DOCKETS 50-266 AND 50-301
SUPPLEMENT 1 TO TECHNICAL SPECIFICATIONS CHANGE REQUEST 218
CORE OPERATING LIMITS REPORT IMPLEMENTATION
POINT BEACH NUCLEAR PLANT, UNITS 1 AND 2

SUPPLEMENT 1 TO TECHNICAL SPECIFICATIONS CHANGE REQUEST 218

Marked-Up Custom Technical Specifications
(23 pages)

Figure 15.2.1-1*
POINT BEACH NUCLEAR PLANT UNITS 1 AND 2
REACTOR CORE SAFETY LIMITS

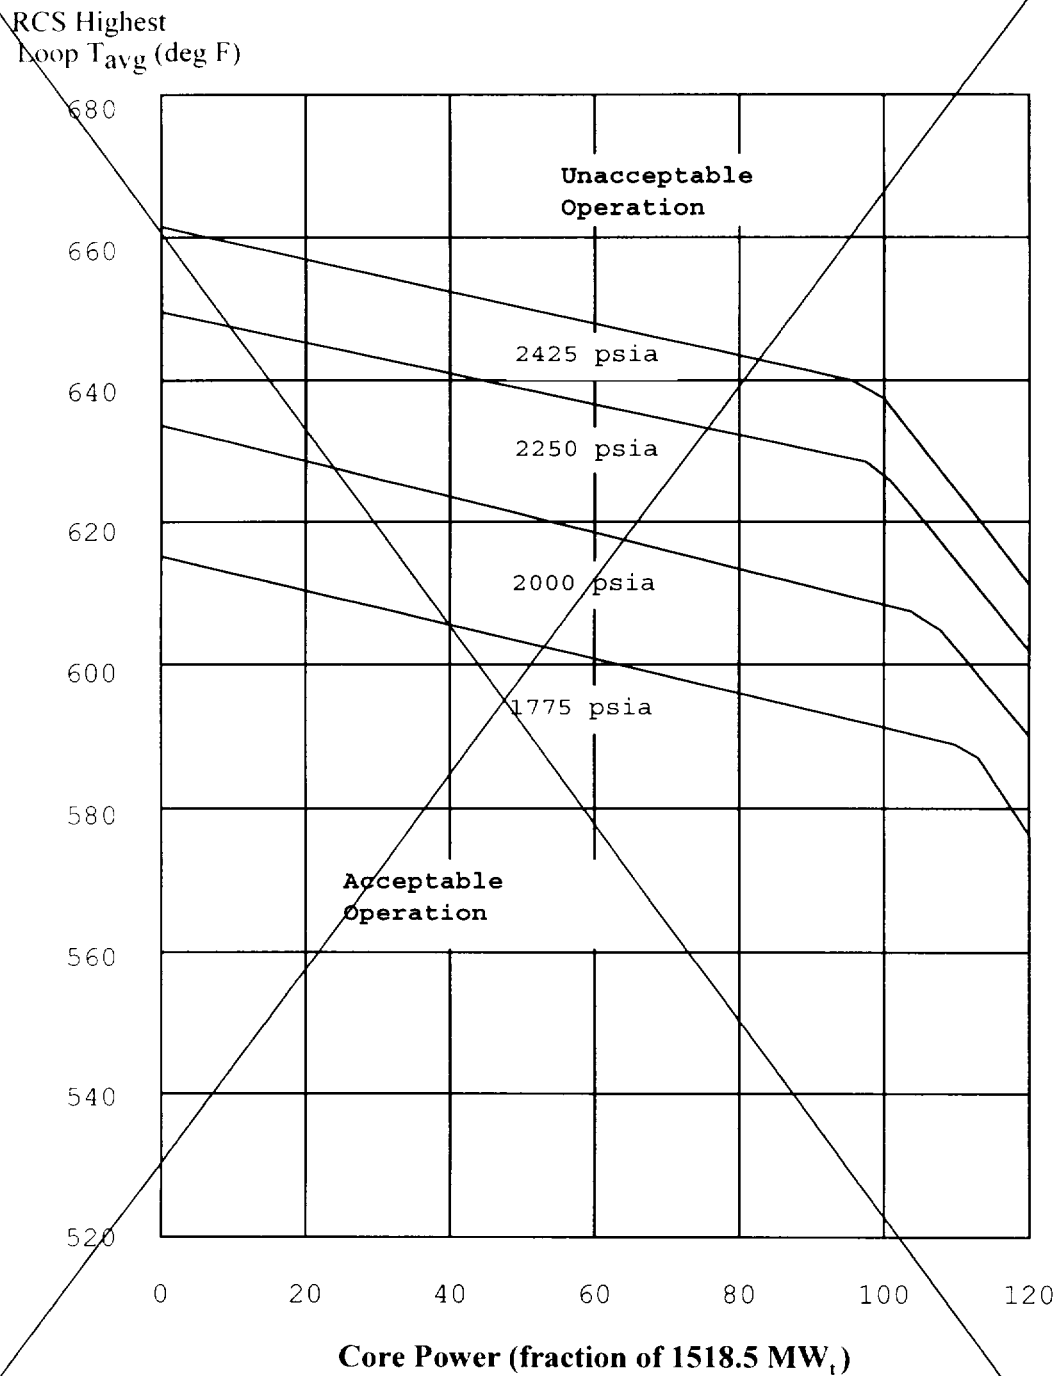
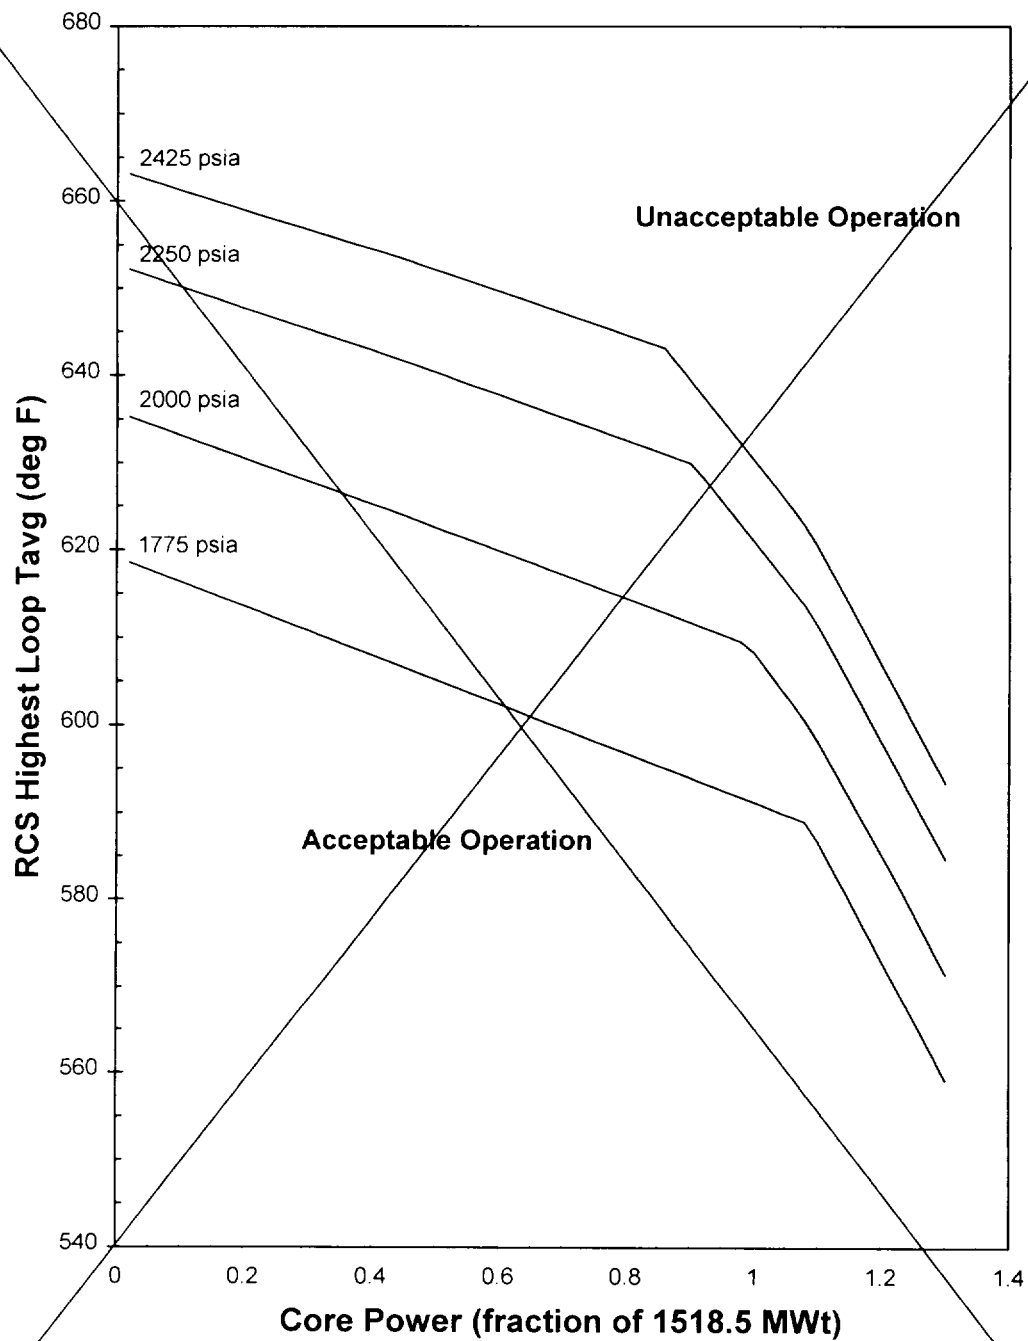
1. The combination of thermal power level, coolant pressure, and coolant temperature shall not exceed the limits ~~shown in Figure 15.2.1-1 or Figure 15.2.1-2 as applicable for Units 1 and 2.~~ The safety limit is exceeded if the point defined by the combination of reactor coolant system average temperature and power level is at any time above the appropriate pressure line.

Insert 1

specified in the COLR in order to preserve the following fuel design criteria:

The departure from nucleate boiling ratio (DNBR) shall be maintained:

- ≥ 1.22/1.21 (typical/thimble) for the WRB-1 correlation – cores not containing 422V+ fuel.
- ≥ 1.24/1.23 (typical/thimble) for the WRB-1 correlation – cores containing 422V+ fuel

OR

- ≥ 1.30 for the W-3 correlation when system pressure is > 1000 psia
- ≥ 1.45 for the W-3 correlation when system pressure is ≥ 500 psia and ≤ 1000 psia

The peak fuel centerline temperature shall be maintained < 5080°F, decreasing by 58°F per 10,000 MWD/MTU of burnup.

G. OPERATIONAL LIMITATIONS

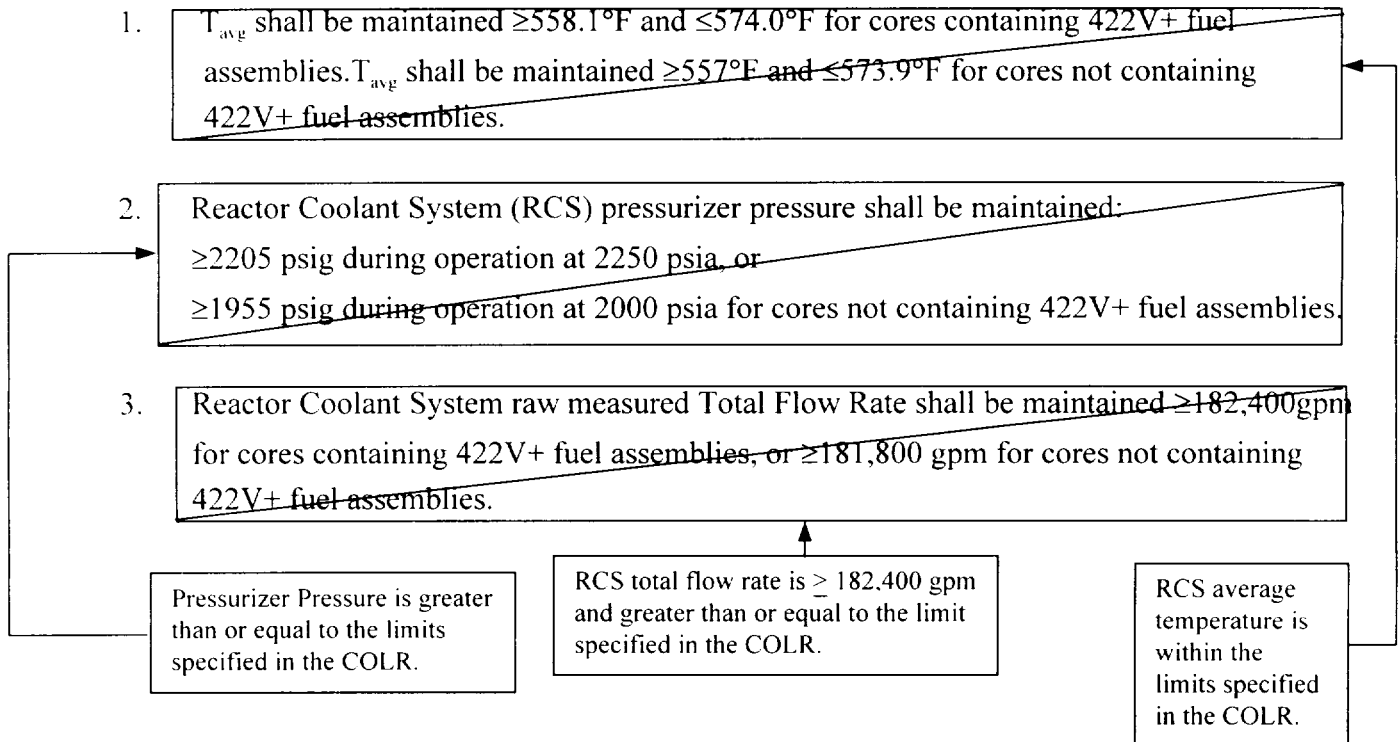
The following DNB related parameters shall be maintained within the limits shown during Rated Power operation:

The reactor coolant system total flow rate of 182,400 gpm ~~for cores containing 422V+ fuel assemblies~~ is based on an assumed measurement uncertainty of 2.4 percent over thermal design flow (178,000 gpm). ~~The reactor coolant system total flow rate of 181,800 gpm for cores not containing 422V+ fuel assemblies is based on an assumed measurement uncertainty of 2.1 percent over thermal design flow (178,000 gpm).~~ The raw measured flow is based upon the use of normalized elbow tap differential pressure which is calibrated against a precision flow calorimetric at the beginning of each cycle.

FIGURE 15.3.10-1

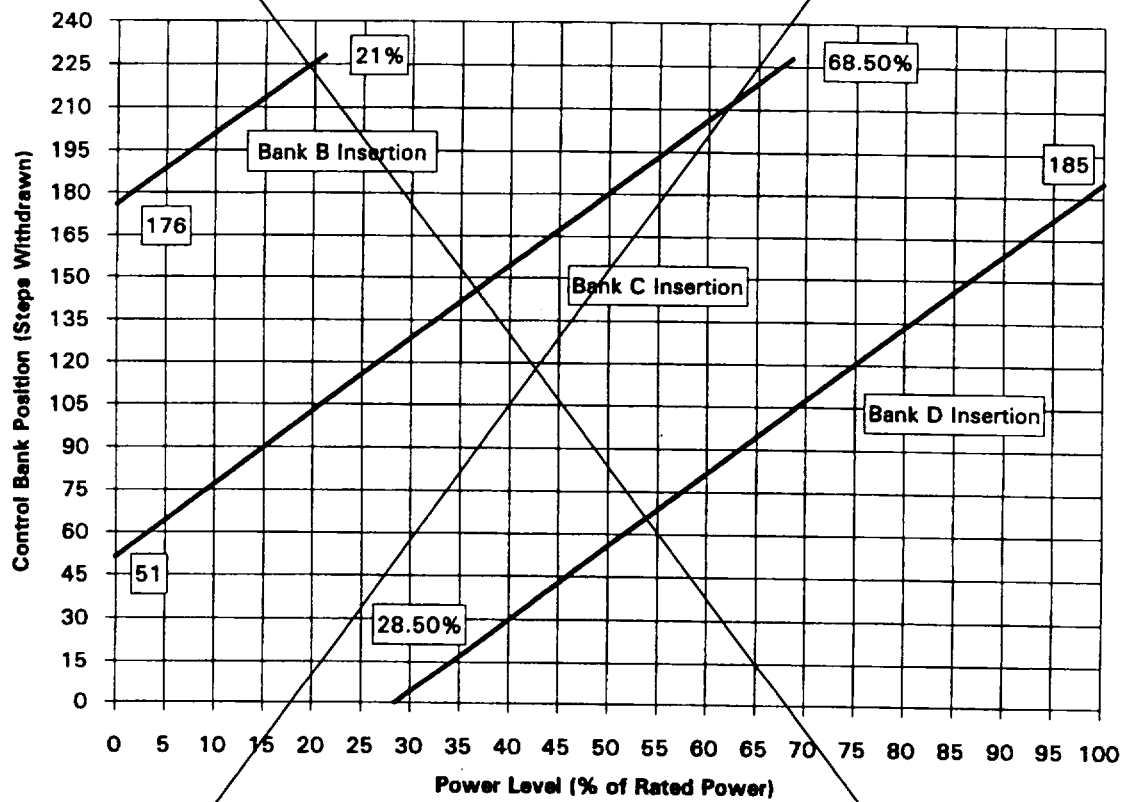
- b. Within two hours fully withdraw the shutdown banks.
- c. If the above actions and associated completion times are not met, be in hot shutdown within the following six hours.
2. When the reactor is critical, the control banks shall be inserted no further than the limits ~~shown by the lines on Figure 15.3.10-1~~. If this condition is not met, perform the following actions:
- specified in the COLR.
- a. Within one hour verify that the shutdown margin exceeds the applicable value ~~as shown in Figure 15.3.10-2~~; OR within one hour restore the shutdown margin by boration;
- specified in the COLR.
- AND
- b. Within two hours restore the control banks to within limits.
- c. If the above actions and associated completion times are not met, be in hot shutdown within the following six hours.

FIGURE 15.3.10-2
REQUIRED SHUTDOWN MARGIN

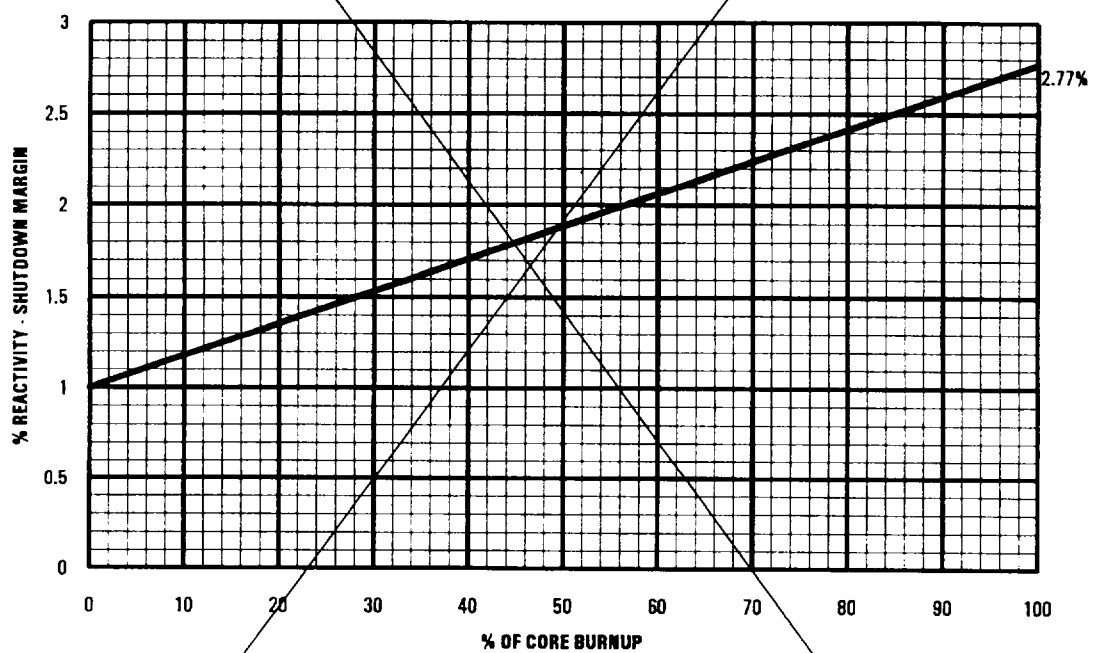
- (a) Within one hour verify that the shutdown margin exceeds the applicable value as shown in Figure 15.3.10-2;
OR provided in the COLR,
- (b) Within one hour restore the shutdown margin by boration;
OR

- (c) Within six hours be in hot shutdown.
- (2) If sustained power operation with an untrippable rod is desired, perform the following actions:
- (a) Within one hour verify that the shutdown margin exceeds the applicable value as shown in Figure 15.3.10-2; OR within one hour restore the shutdown margin by boration;
AND provided in the COLR,

- (3) If more than one rod is determined to be untrippable, perform the following actions:
- (a) Within one hour verify that the shutdown margin exceeds the applicable value as shown in Figure 15.3.10-2; OR within one hour restore the shutdown margin by boration;
AND

- (a) Within one hour verify that the shutdown margin exceeds the applicable value as shown in Figure 15.3.10-2; OR within one hour restore the shutdown margin by boration;
AND provided in the COLR,

- (c) Verify that the shutdown margin exceeds the applicable value as shown in Figure 15.3.10-2 once per twelve hours;
AND provided in the COLR,
 - (d) Within 72 hours verify that measured values of $F_Q(Z)$ are within limits;
AND

- provided in the COLR, (a) Within one hour verify that the shutdown margin exceeds the applicable value as shown in Figure 15.3.10-2 OR within one hour restore the shutdown margin by boration;
AND

- a. Within one hour verify that the shutdown margin exceeds the applicable value as shown in Figure 15.3.10-2, OR within one hour restore the shutdown margin by boration;

the COLR

FIGURE 15.3.10-3

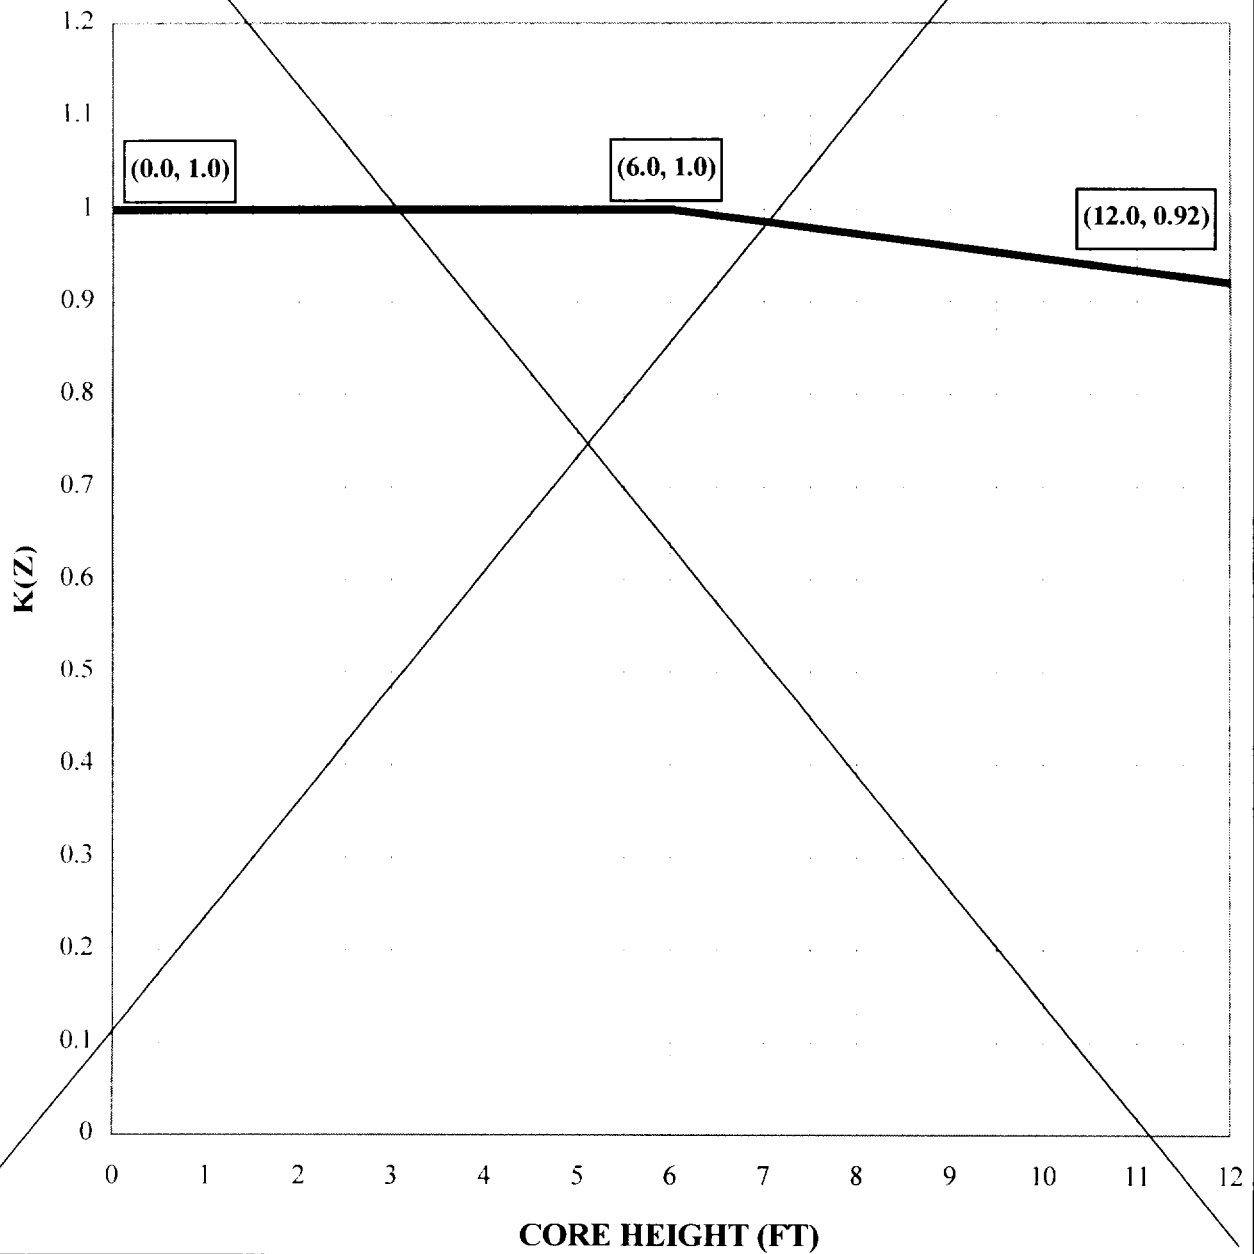
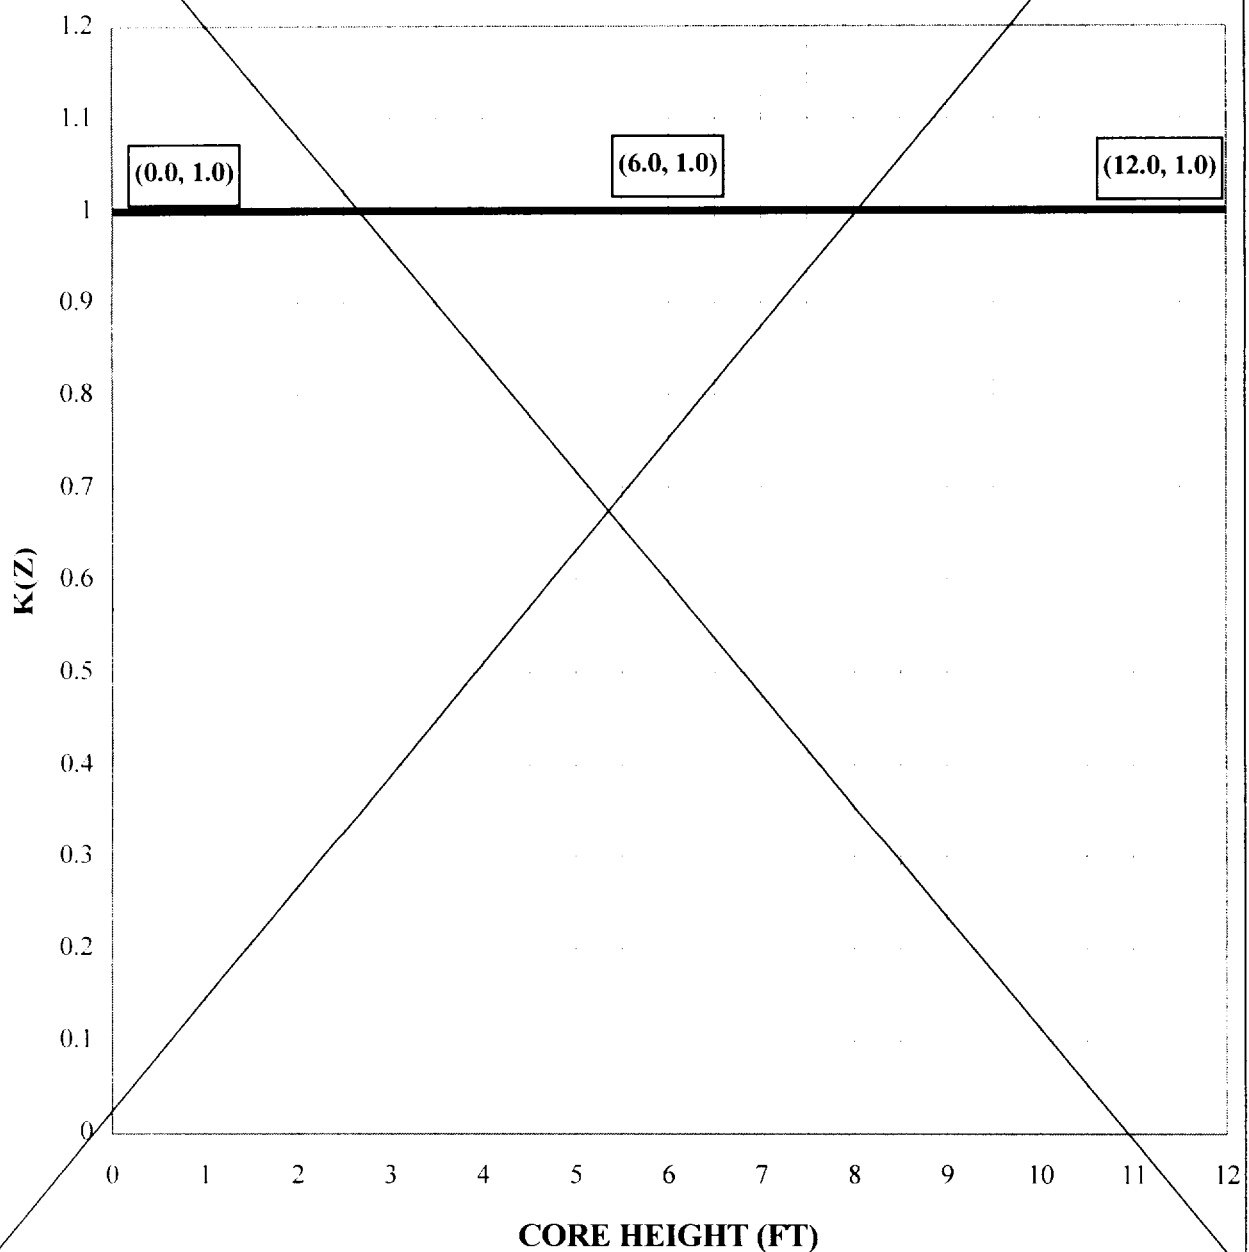
~~Where P is the fraction of full power at which the core is operating, K(Z) is the function in Figure 15.3.10-3 or Figure 15.3.10-3a, as applicable, and Z is the core height location of F_Q .~~

be within the limits specified in the COLR.

FIGURE 15.3.10-4

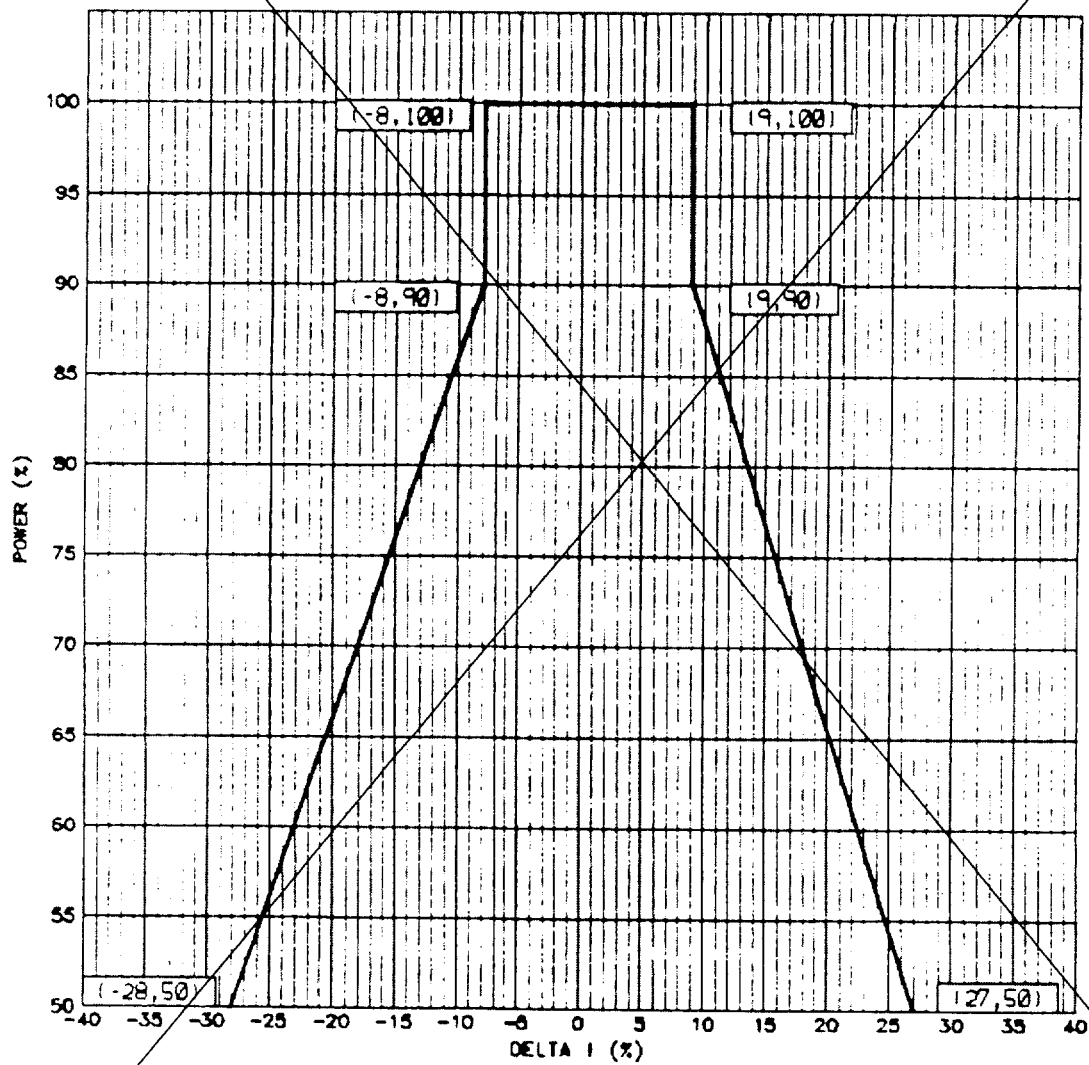
- a. During power operation with thermal power ≥ 50 percent of rated thermal power, the axial flux difference shall be maintained within the limits specified in Figure 15.3.10-4 the COLR.
